**STATE OF HAWAII  
DEPARTMENT OF LAND AND NATURAL RESOURCES  
OFFICE OF CONSERVATION AND COASTAL LANDS  
HONOLULU, HAWAII**

***October 26, 2018***

**REGARDING:** Proposed Conservation District Use Application (CDUA) OA-3821 for the  
*Grossman Scour Apron Erosion Control Project*

Vertical seawall with scour apron protection, property to the north (high tide swash top left corner). Photo date: July 2015.

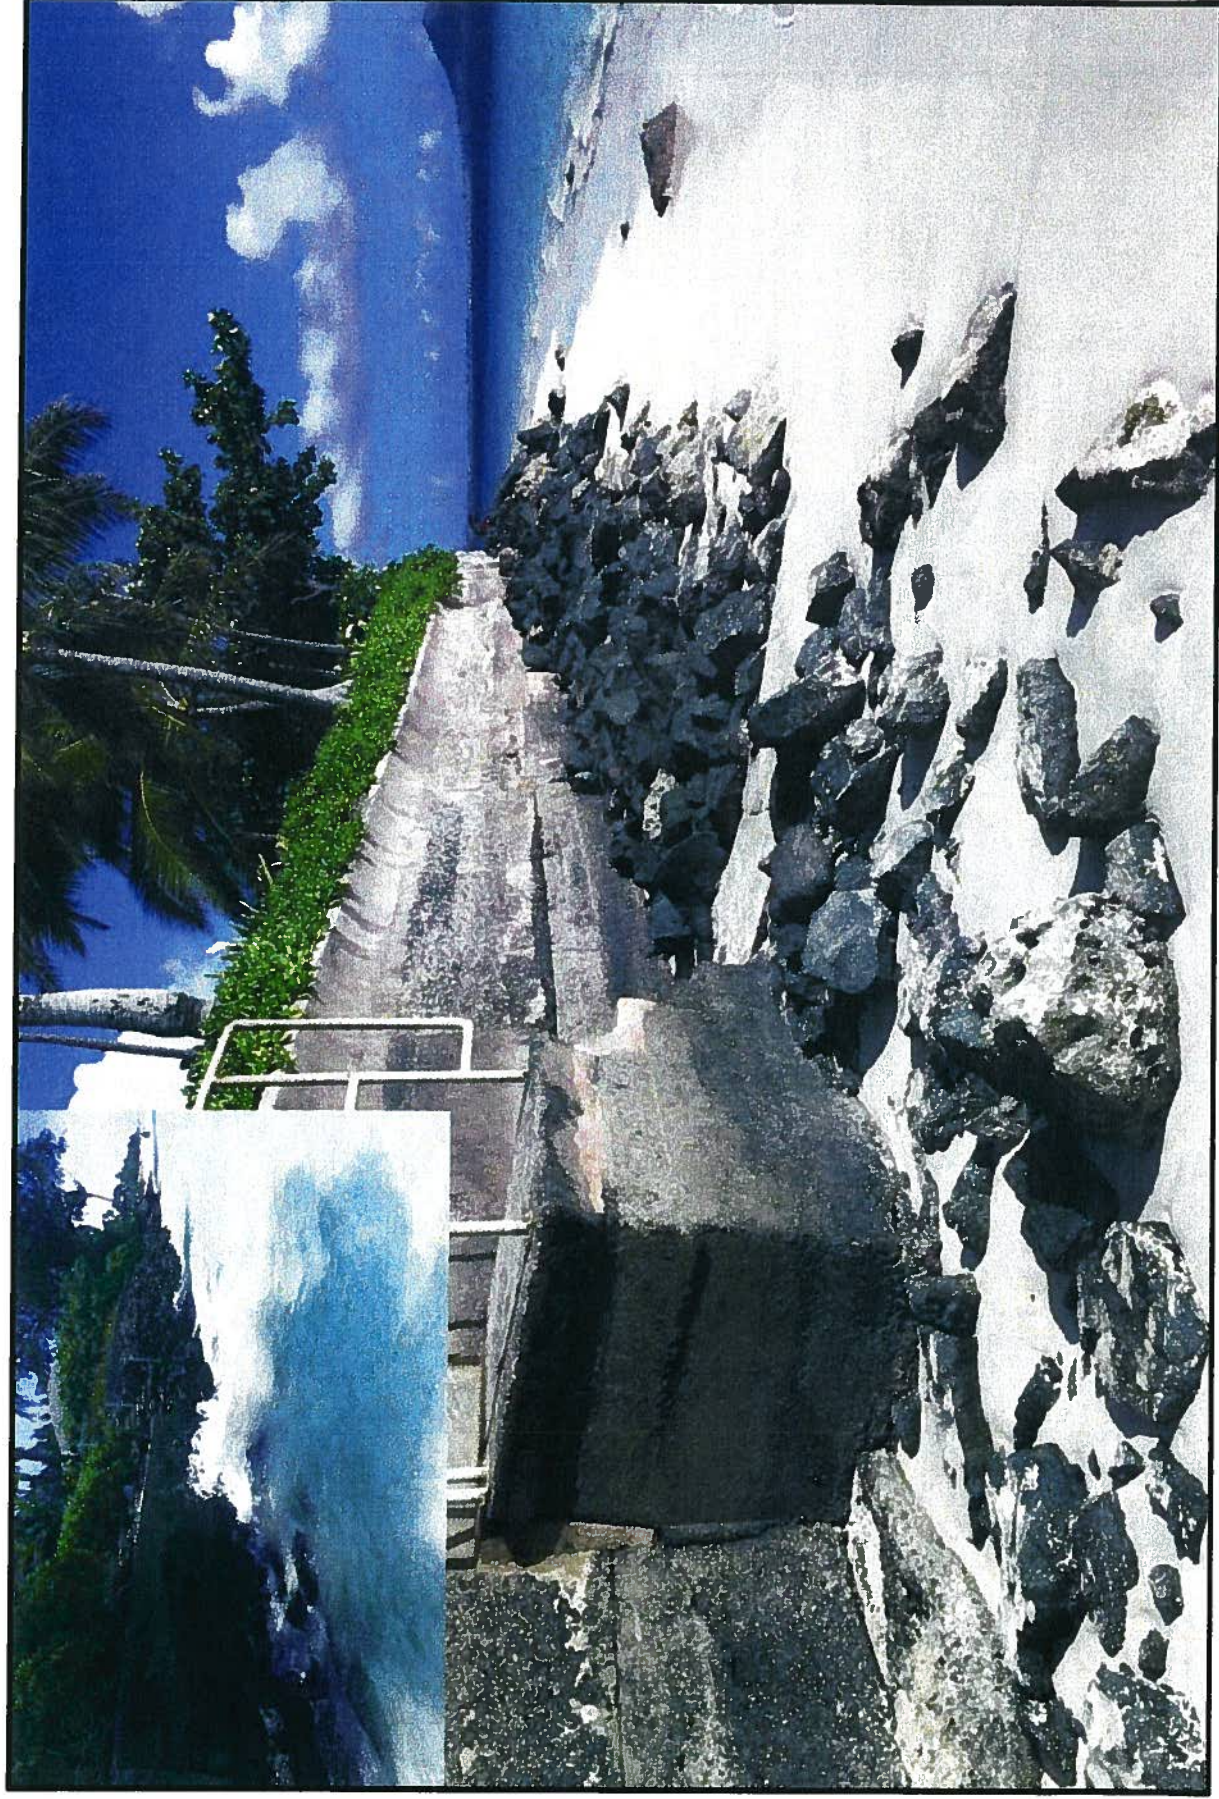
The applicant states that the proposed rip-rap toe apron in front of the subject property's seawall is similar to the existing apron that fronts the seawall at the neighboring property. The apron will be visually consistent with the local area and is appropriate for this moderate wave energy shoreline environment. The beach in front of the subject's property is

*OCCL staff notes that a large rock revetment located on the beach is not necessarily compatible with the natural conditions of this site which is a sandy beach, and is considered state unencumbered lands for use by the public.*

EXHIBIT 8 CDUA: OA-3821

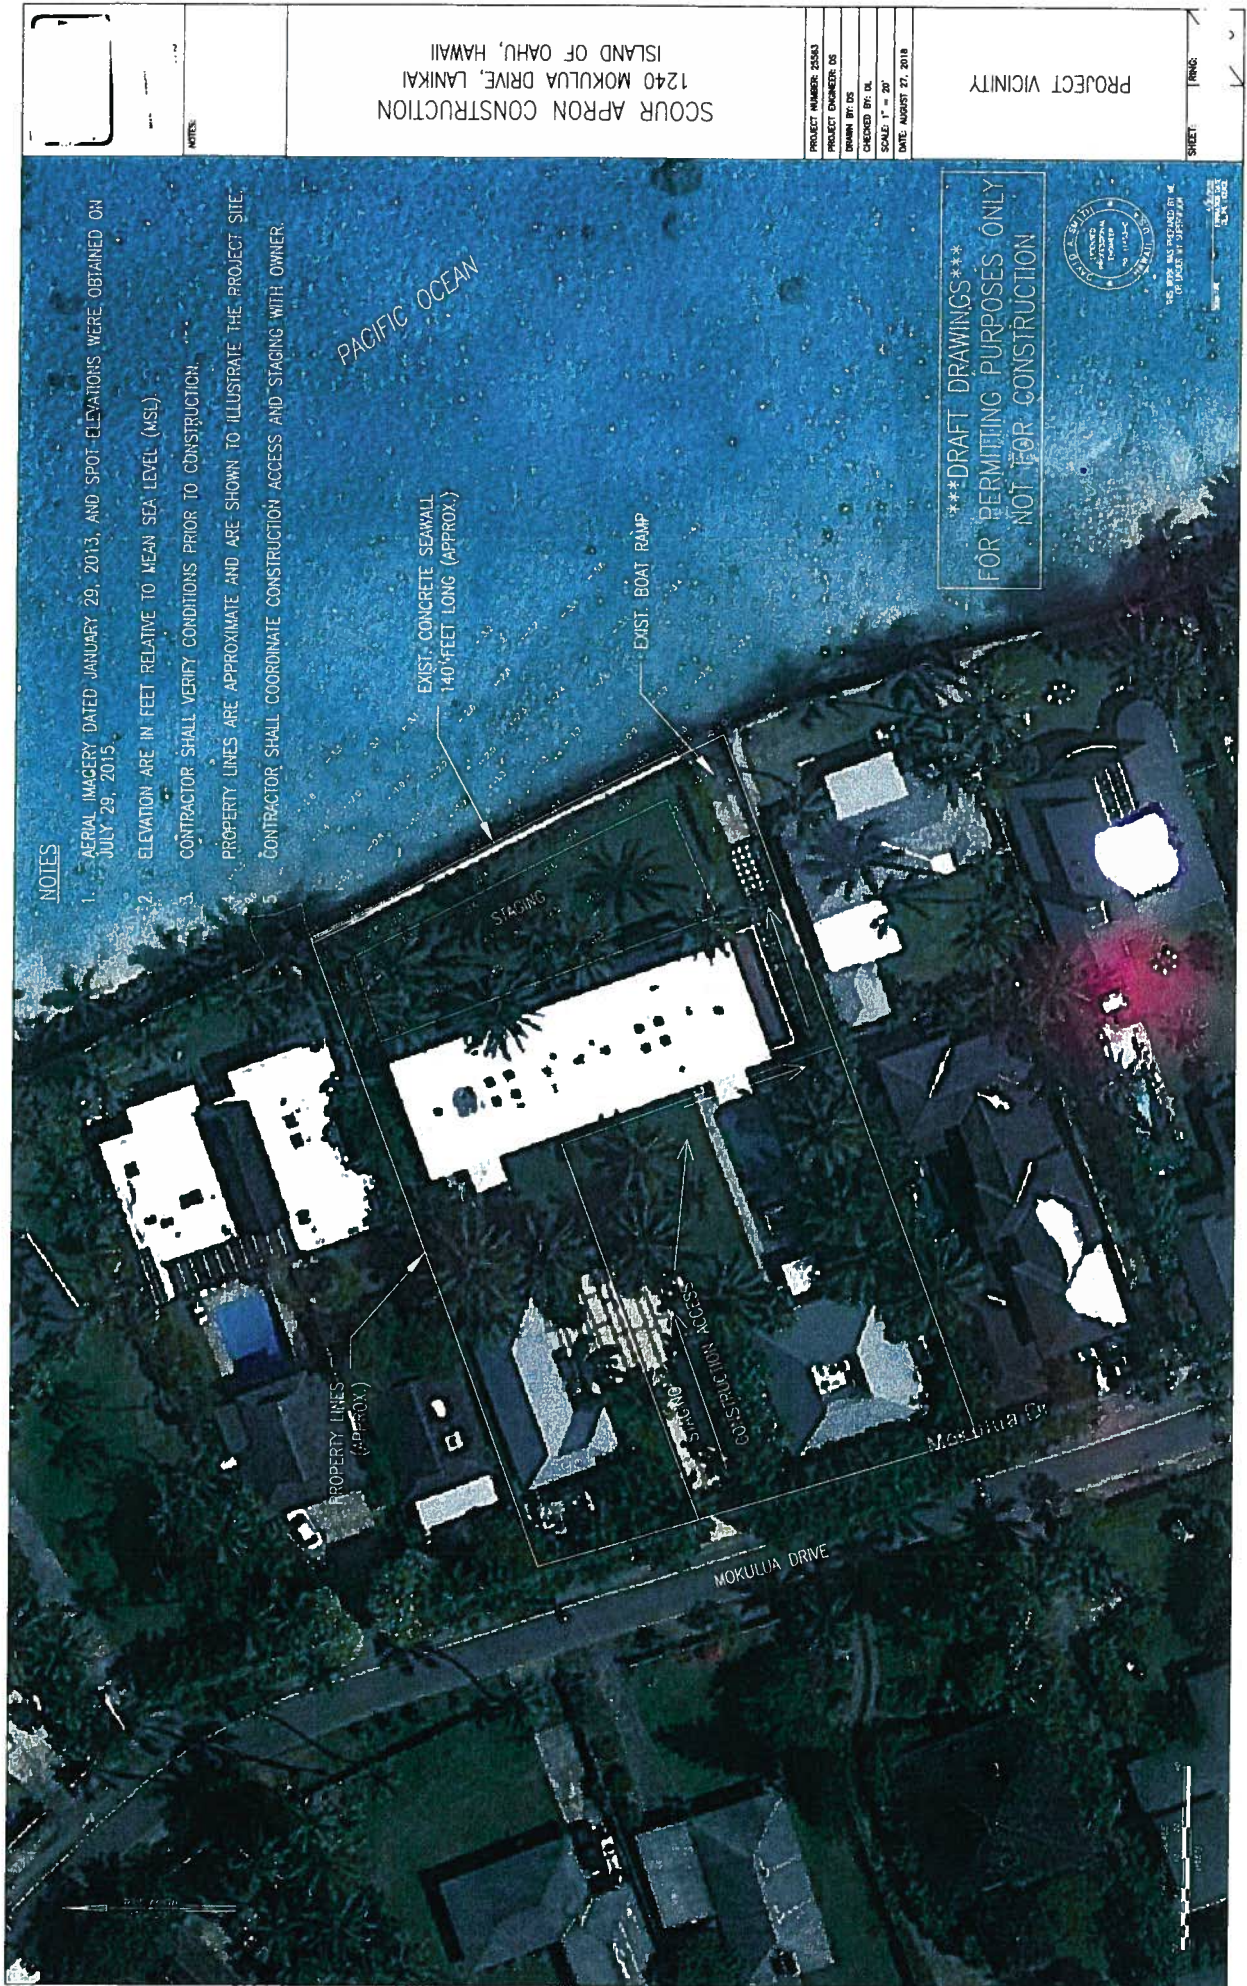
The applicant states that all equipment will operate from the subject parcel and no equipment will operate in the water or from the beach area (**Exhibit 8**). Additionally, the applicant has established a number of Best Management Practices (BMPs) to minimize impacts to the environment, these include (but are not limited to): containment devices to minimize turbidity (e.g., silt curtains, or fences) (**Exhibit 9**), making sure all construction materials are free of invasive plant or animal species prior to placement in the water; avoidance of seagrass or coral beds during construction, and stockpile construction materials well away from ocean wave impacts or flooding.

- B. OP recommends that the Final EA consider the findings in the “Hawaii Sea Level Rise Vulnerability and Adaptation Report, 2017”
- C. The Final EA should present the location of the potential staging and stockpiling areas and provide confirmation from the Department of Planning and Permitting for Special Management Area (SMA) project requirements.
